**MEETING OF THE DESIGN REVIEW BOARD
MORRIS N. BROAD COMMUNITY CENTER
1175 95TH STREET
BAY HARBOR ISLANDS, FL 33154**

REVISION # 1 REVISION DATE: 07/18/23

Subject: Site Development Plan Application - Revision
Proposed New 9 DU Multifamily Residential Complex
Revisions to Approved Site Development Plan
1055 93rd Street
Bay Harbor Islands Acct. No. SPR22-000026
MMPA Acct. No. 01-0702-1144

Revision to Approved Planning and Zoning Board Submission

Sheet A-12, Level 2 Floor Plan

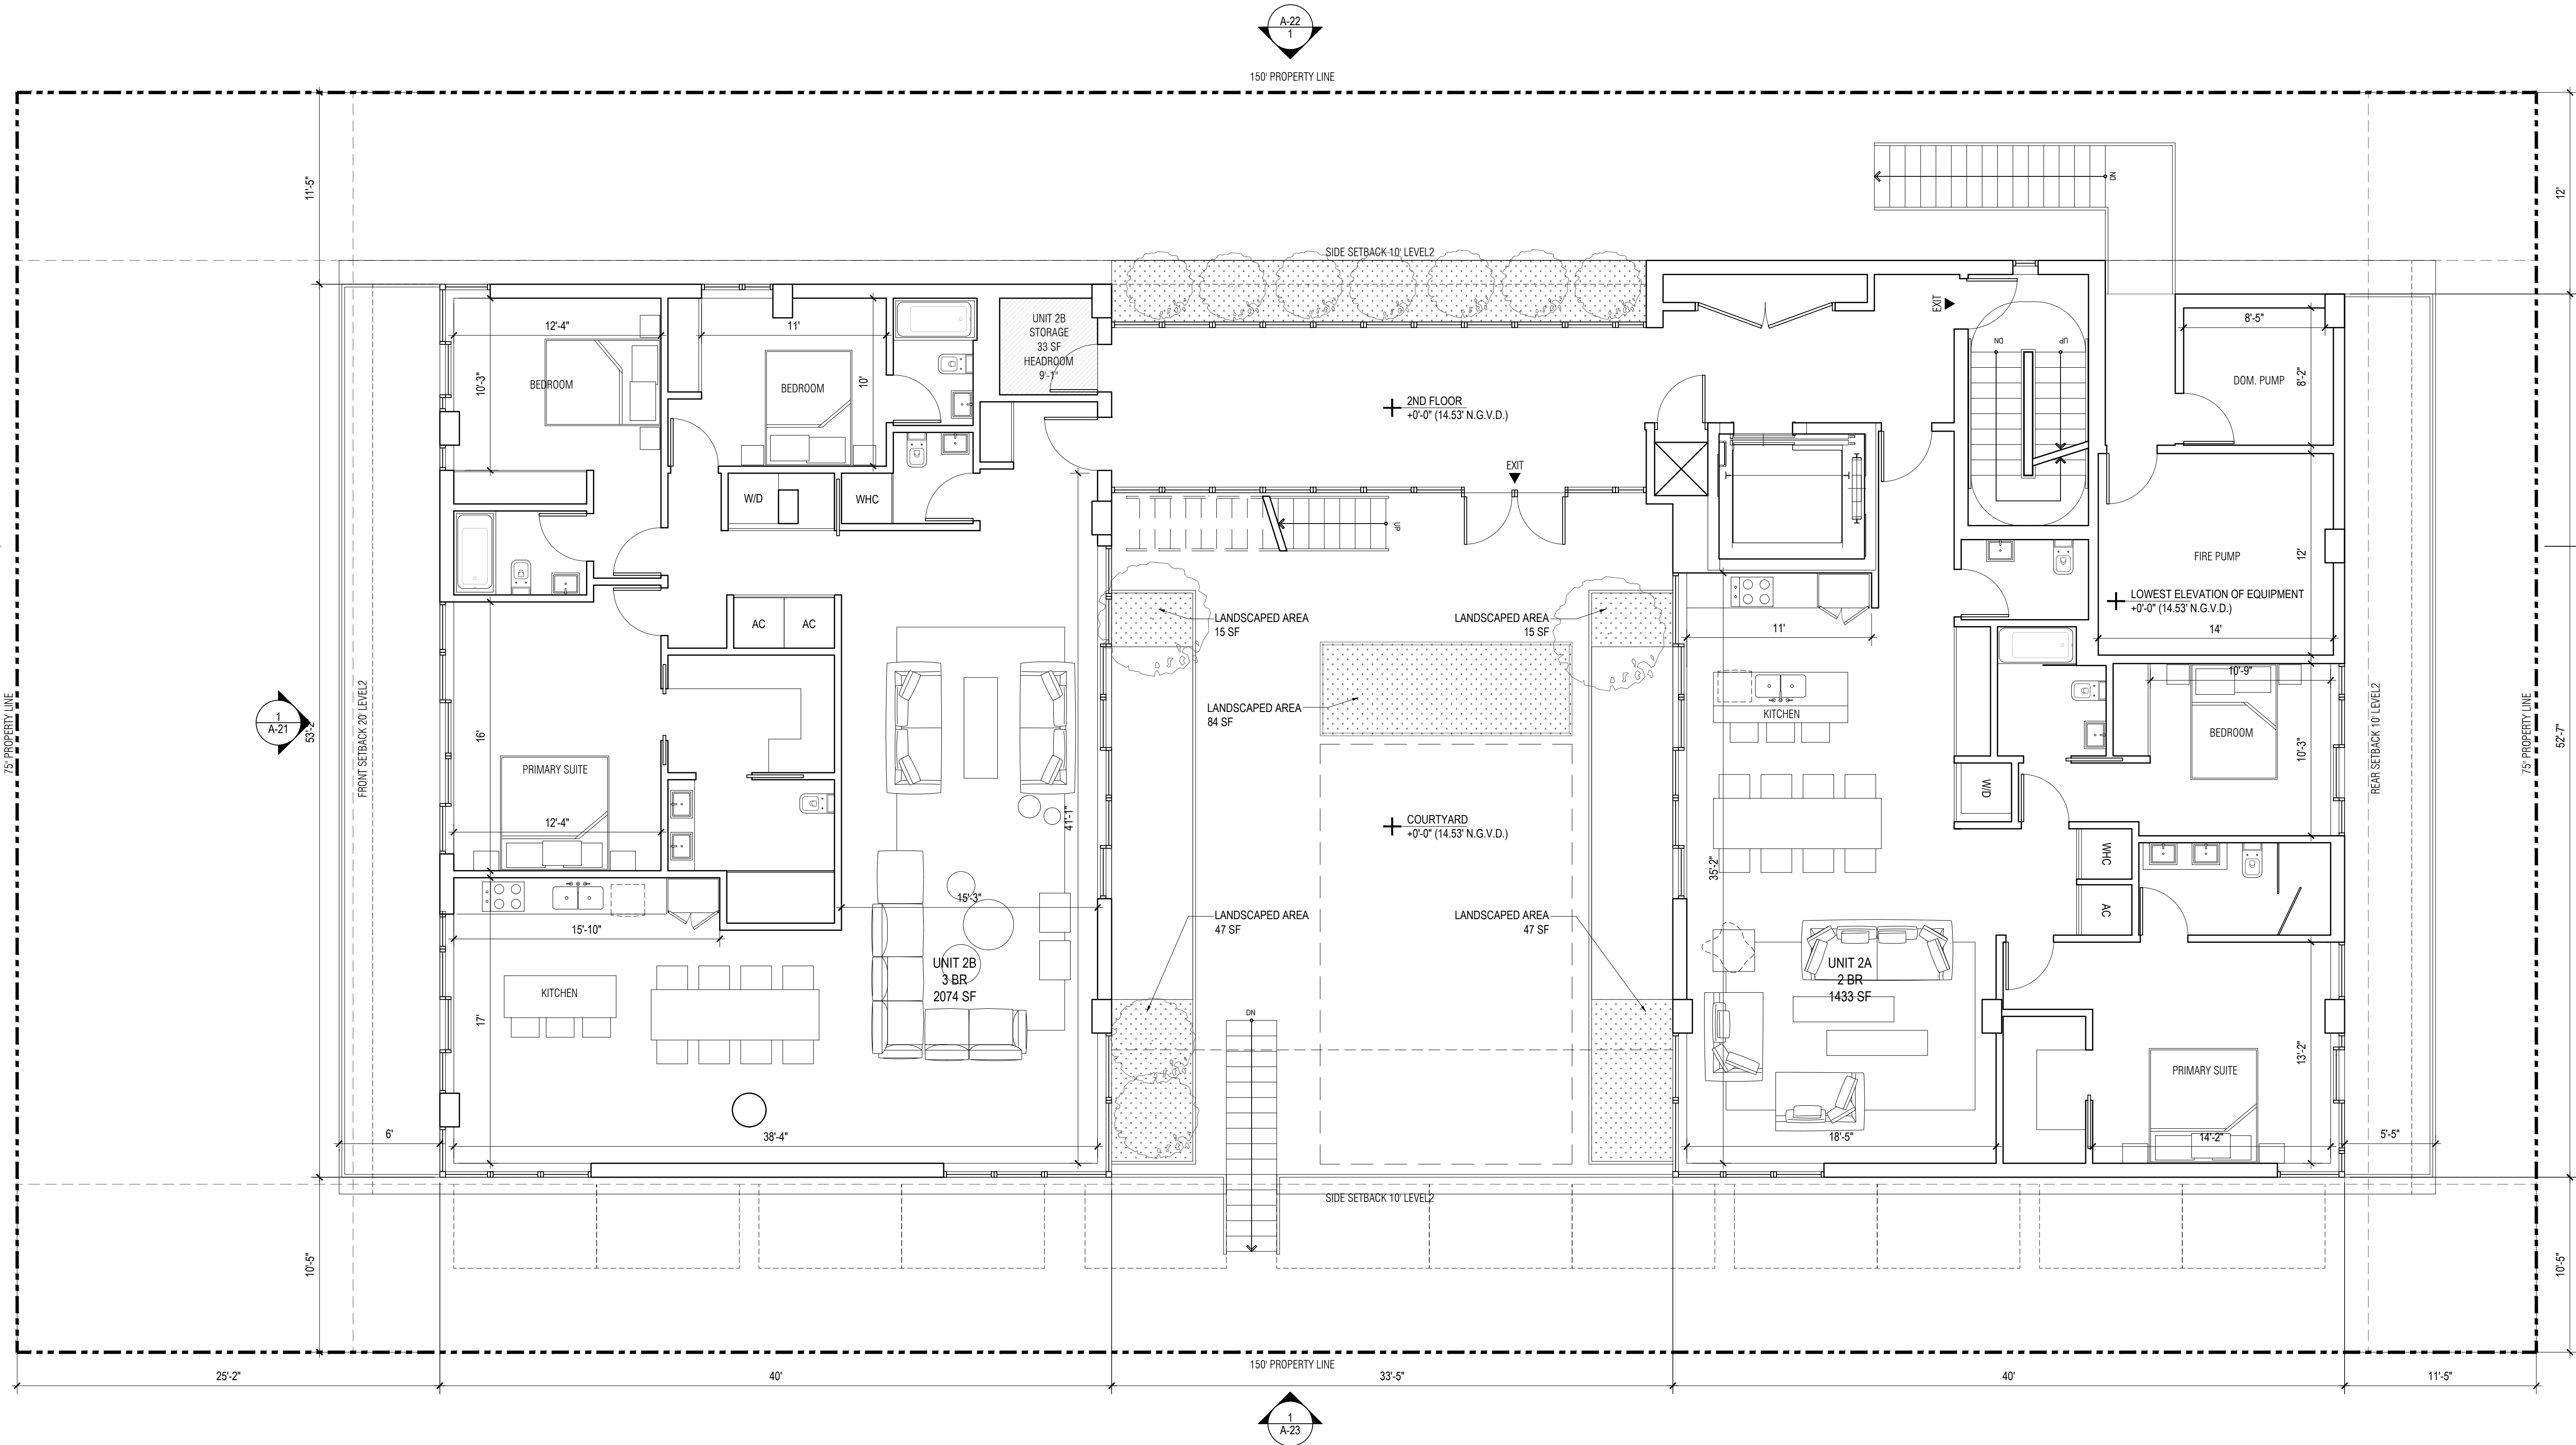
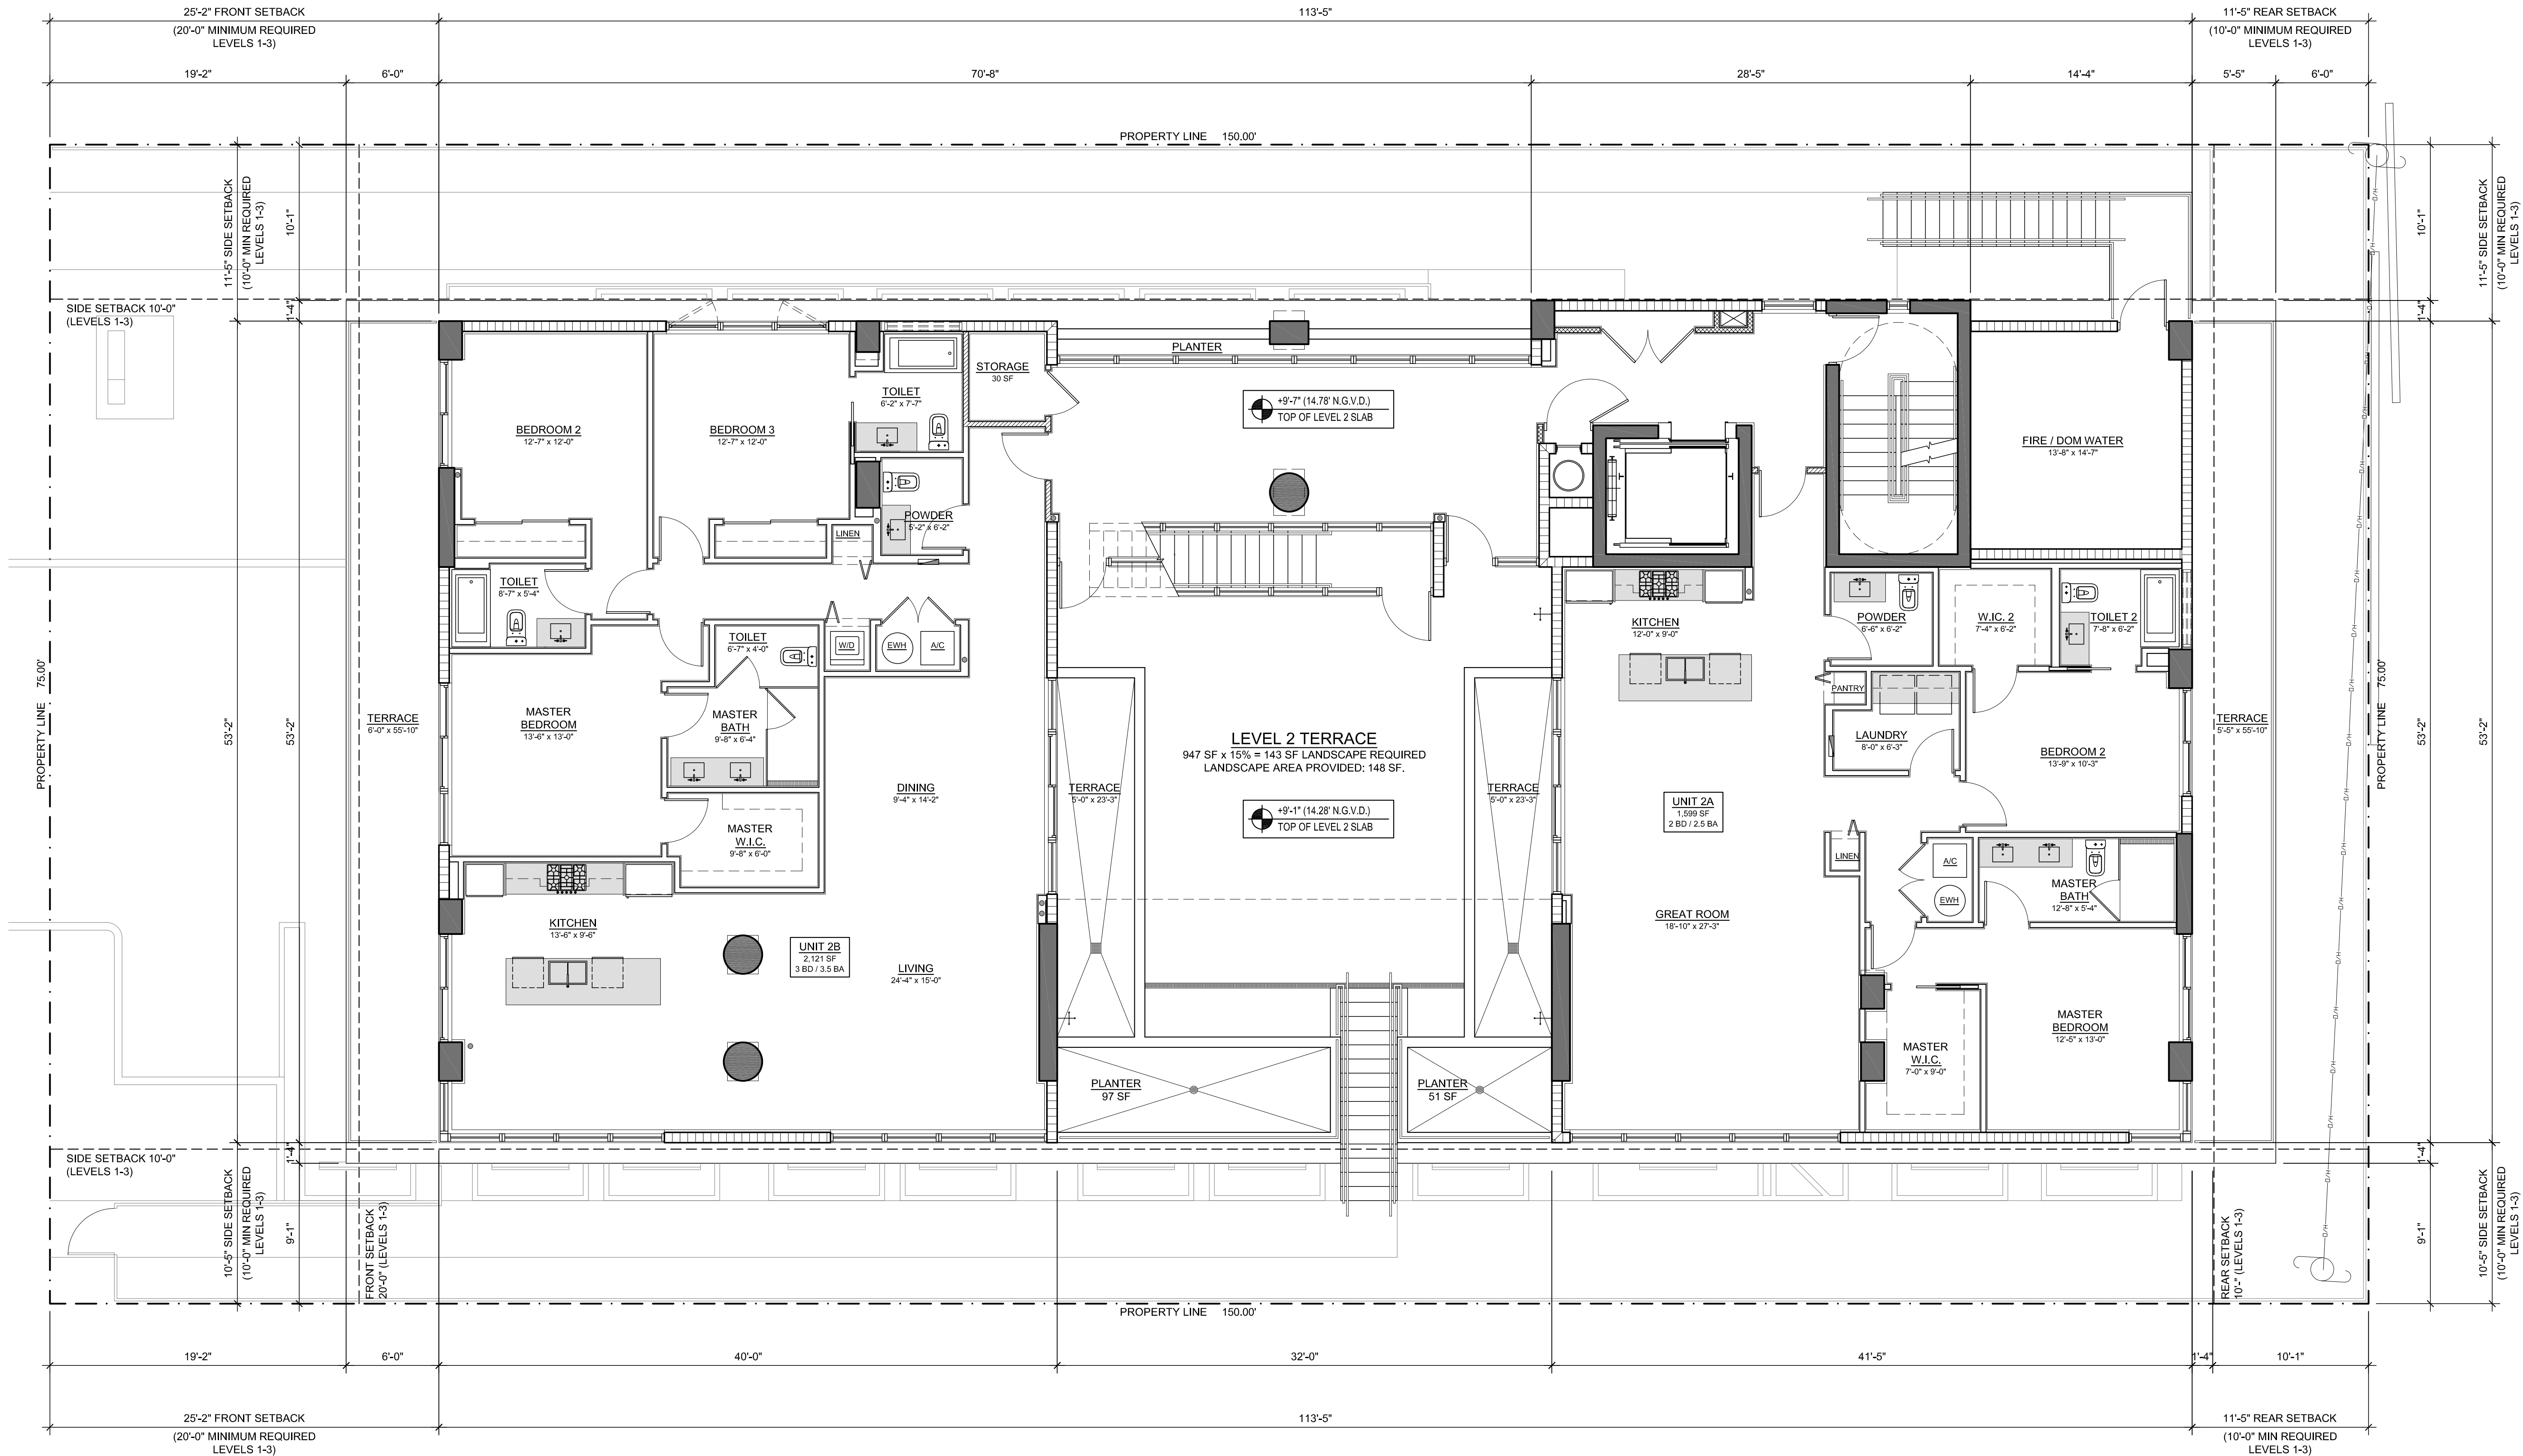
1. Modifications to the design of the Level 2 Exterior Terrace in order to meet Miami-Dade Fire Egress requirements
2. Modifications to the exterior window/door placements and sizes due to changes to the unit layouts and coordination with Structural
3. Modifications to the interior unit layouts
4. Modifications to the Fire and Domestic Water Pump rooms in order to combine them into one room
